DN-GEO-DESIGN REPORT
FOR KNOCKSHANVO WIND
FARM

PROPOSED TEMPORARY TRANSITION COMPOUND ON N69 FOR ABNORMALLY SIZED LOADS LOCATED IN COUNTY LIMERICK

DN-GEO-03030 Design Report

Client: Knockshanvo Wind Farm Development
August 9th , 2024
AL Project No: 8880

Figure 2 Layout of Proposed Temporary Transition Compound - 3m x 220m visibility splays

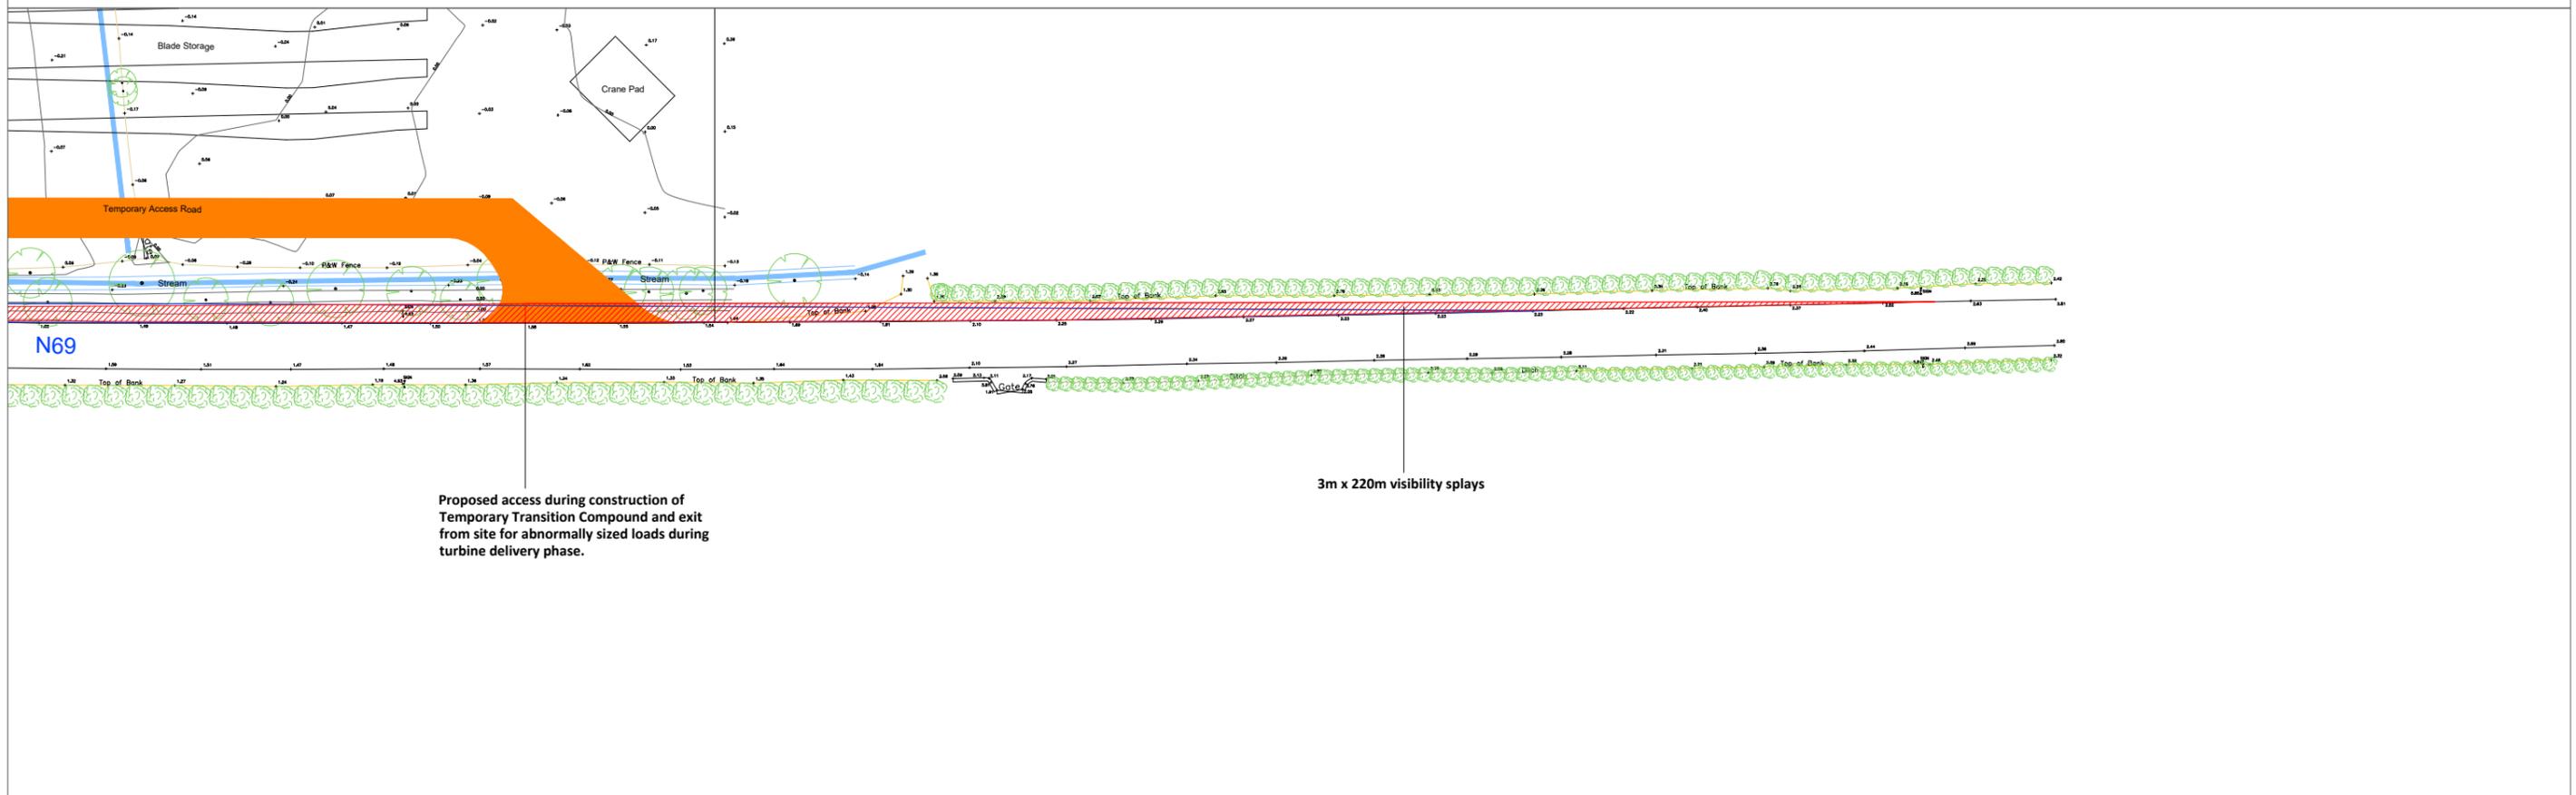
Problem 2.1 – Sightlines partially obscured by field boundary, Temporary Transition Compound, field boundary flanking accesses – The Audit Team notes sightlines to the left appear to be partially obscured by the existing field boundary, which includes a ditch foliage and some trees. This could lead to side impact type collisions within the access junction’s conflict zone.

The Audit Team recommends that the ditch and boundary should be modified to ensure that an appropriate sightline is provided at the location.

The Design Team Response is as follows - It is acknowledged that visibility splays are constrained at the location of the proposed Temporary Transition Compound. Appropriate traffic management measures are set out in Section 15.1.2.3 of the EIAR. During the construction of the proposed TTC access to and from the site off the N69 will be controlled by traffic management measures, including temporary signage in accordance with the “*Traffic Signs Manual, Section 8 – Temporary Traffic Measures and Signs for Road Works*” (DoT now DoTT&S) and “*Guidance for the Control and Management of Traffic at Roadworks*” (DoTT&S). Construction staff (flagman) will be present at this location during all times that deliveries are made to and from the site. The site will be closed to all traffic by means of fencing at all other times.

It is also noted, as shown in Figure 2, that with minor trimming of existing hedges and trees that the full 3m x 220m visibility splays are available, although not required with the traffic management measures discussed above.
